Annual Monitoring Report

Project Name: Junes Branch Stream Restoration

RE: Junes Branch Stream Restoration Site: MY5 Monitoring Report (NCDMS ID 95027)

Listed below are comments provided by DMS on January 17, 2019 regarding the Junes Branch Stream Restoration Site: Year 5 Monitoring Report and RES' responses.

**Hidgon Branch
Longitudinal Profile
Staioning 300+46 to 304+22**

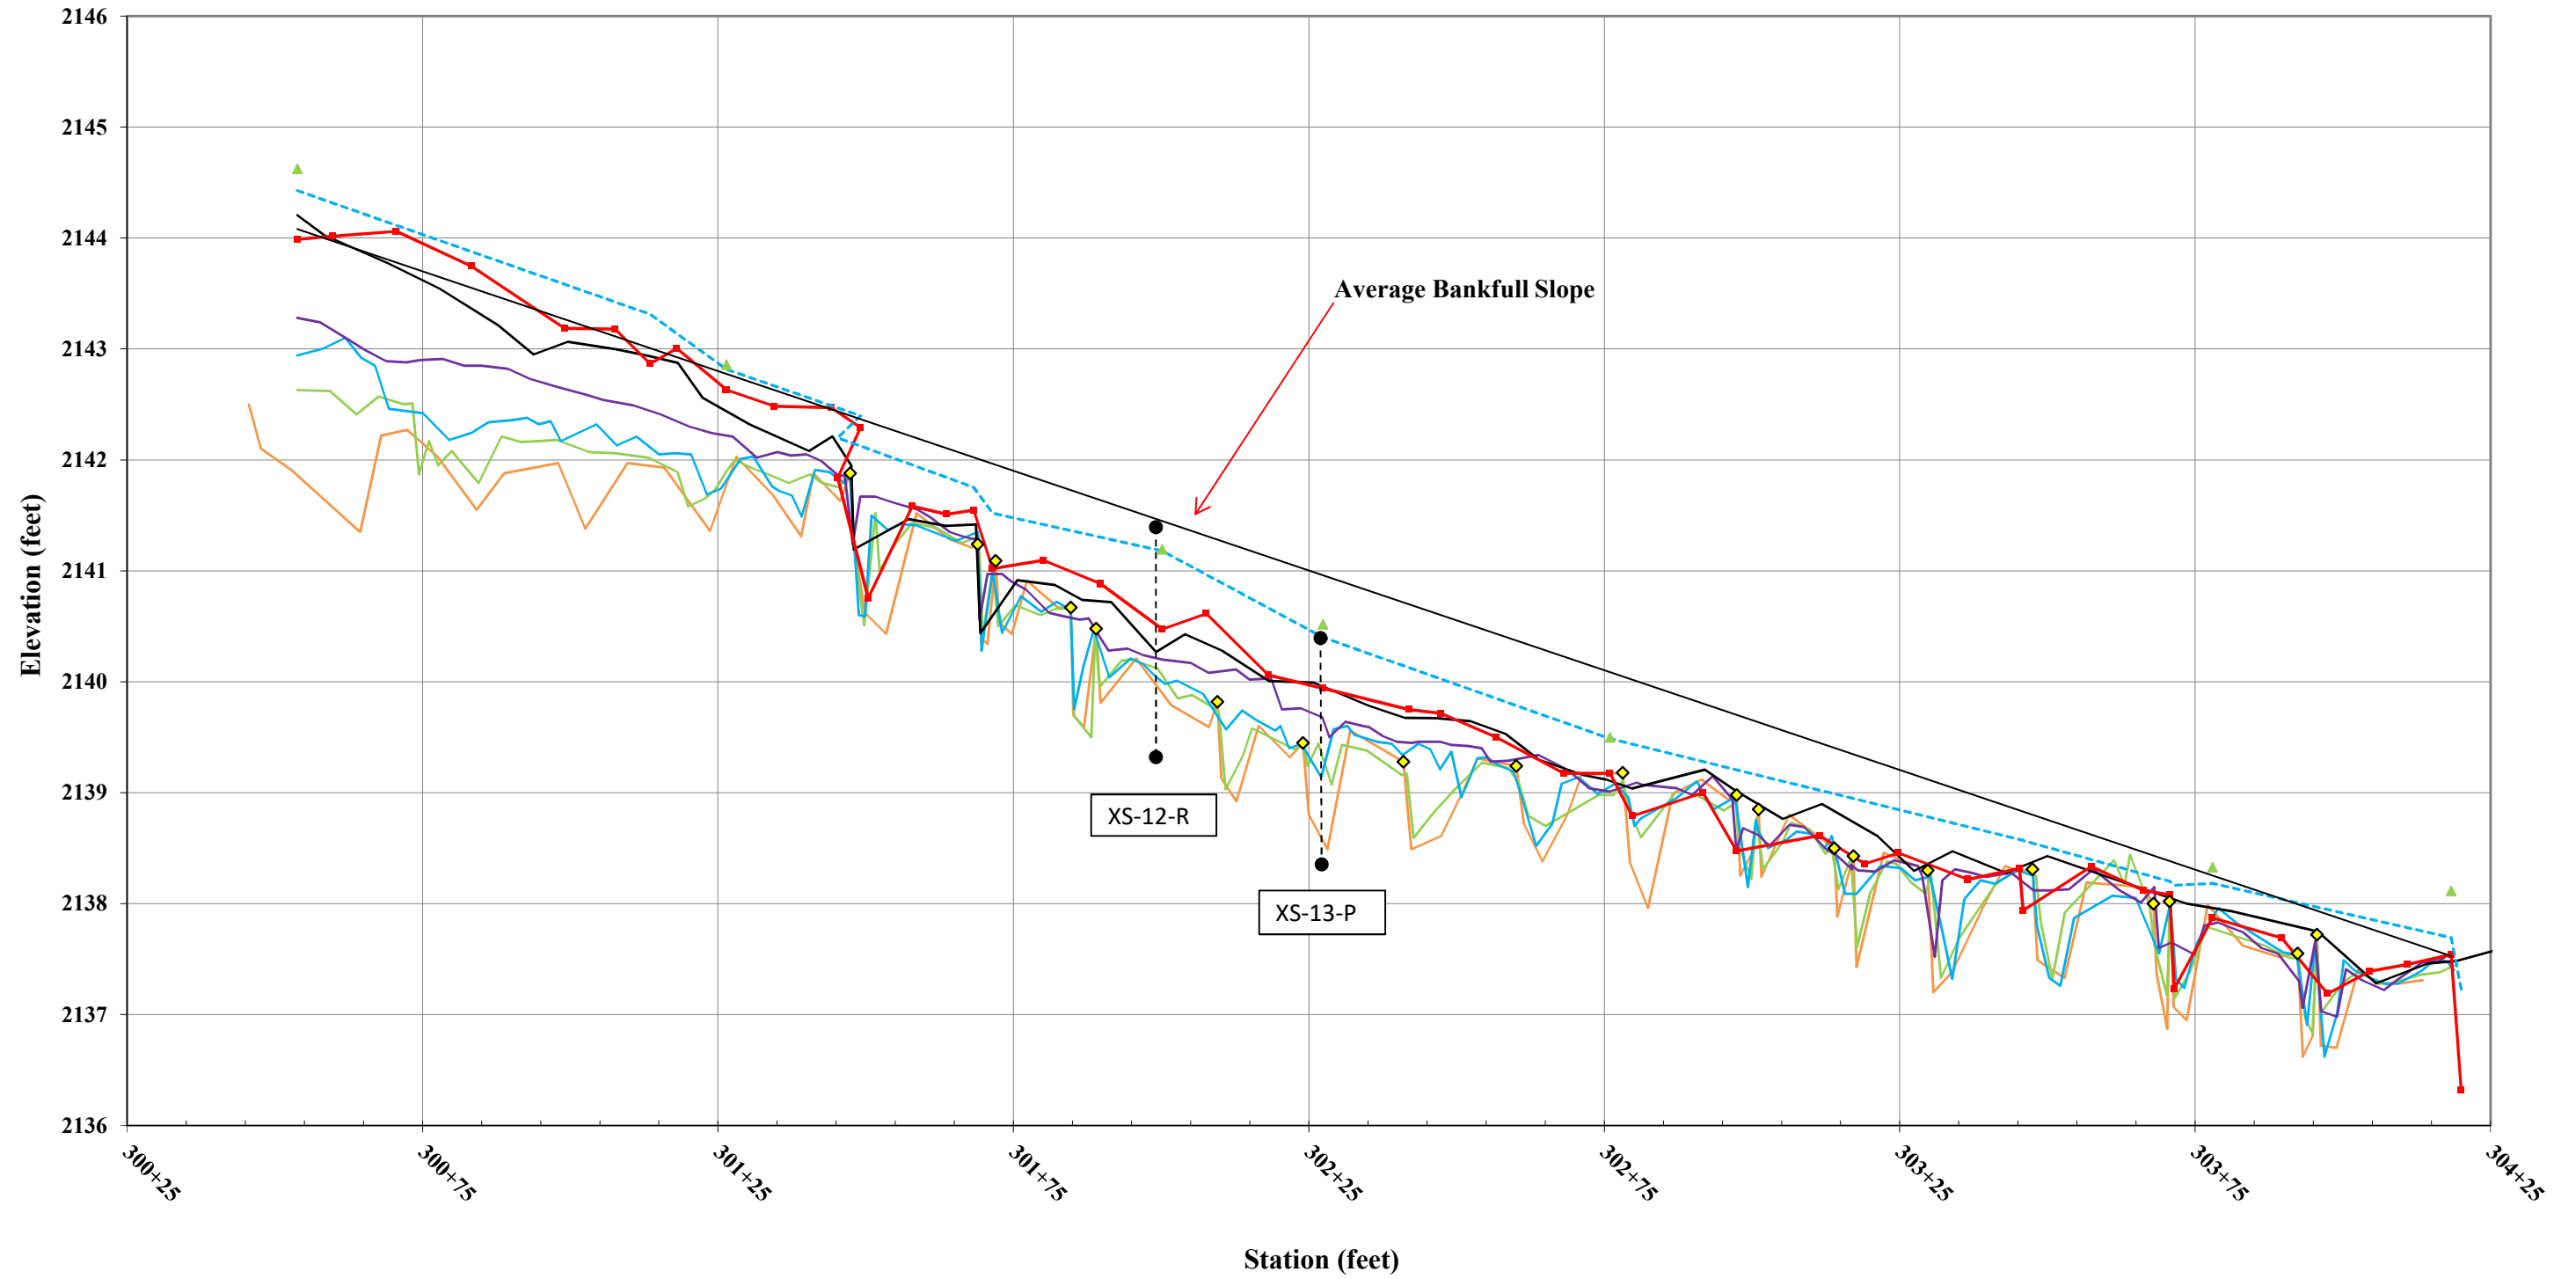
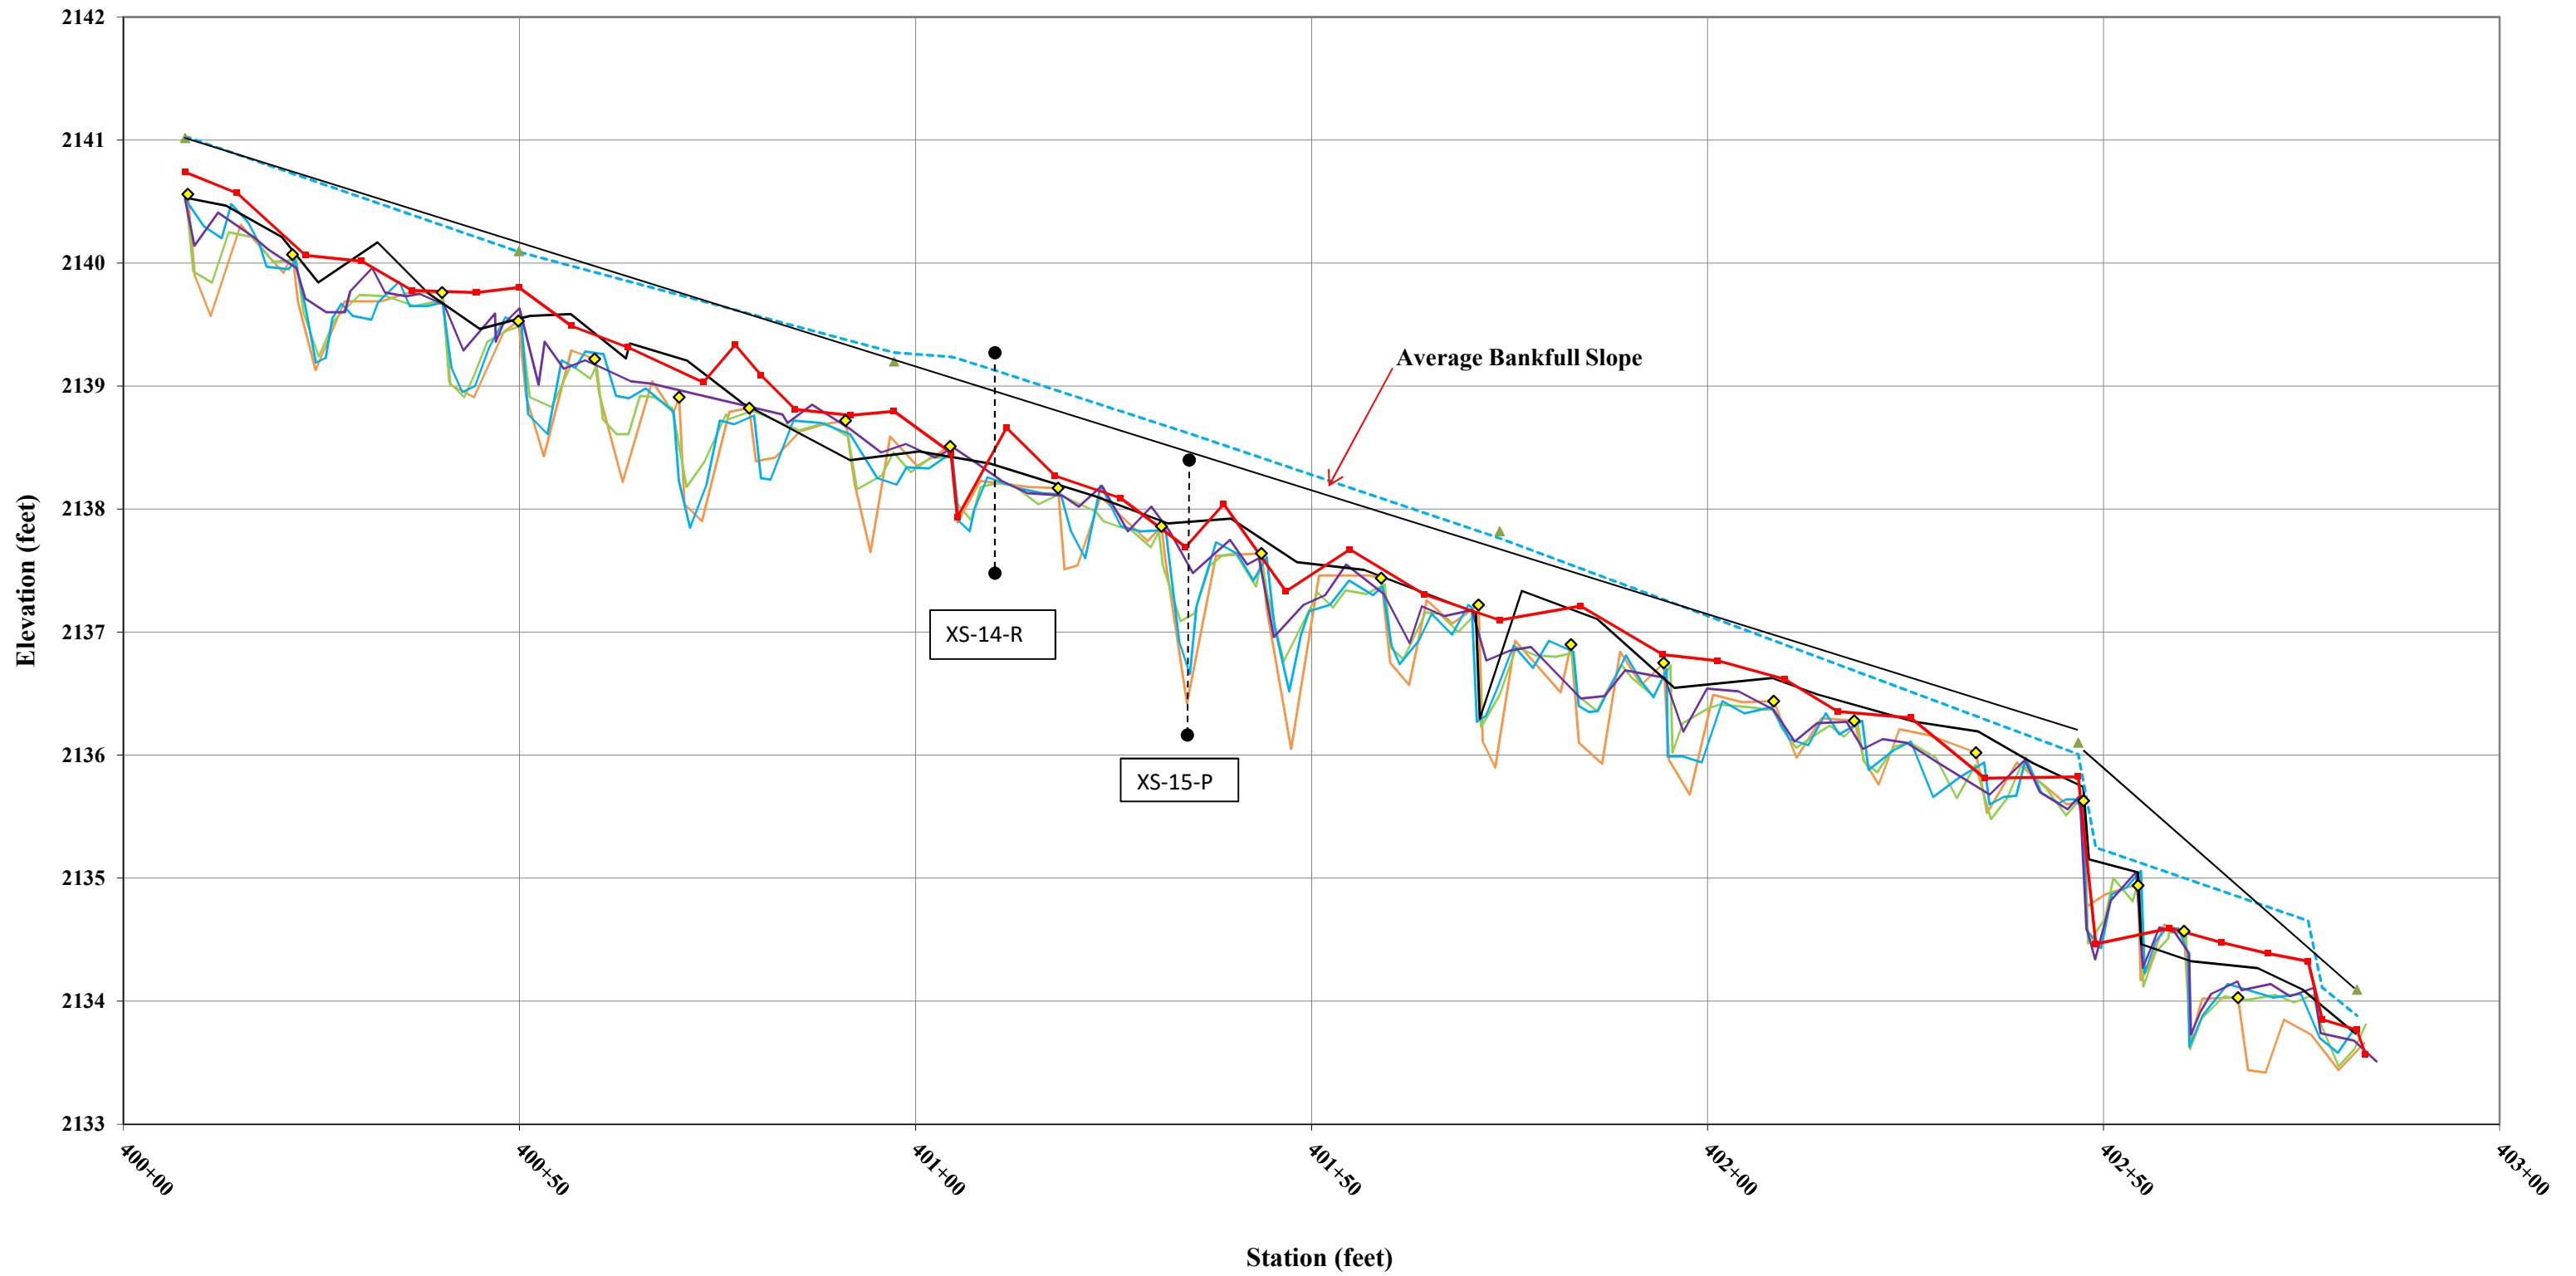
Table 5 (Doris Branch and Higdon Branch): The table currently indicates that both reaches are 100% stable and performing as intended. The cross sections and longitudinal profiles indicate aggradation on both reaches over the monitoring term. Please review, confirm the assessment and update the report if necessary.

[The aggradation issue on Doris Branch and Higdon Branch has stabilized in MY5 and has improved in some areas especially when compared to MY3 and MY4. Despite an increase in bed elevation, both reaches still maintain riffles and pools. Based on this data, RES proposes credits be released in full for these two reaches.](#)
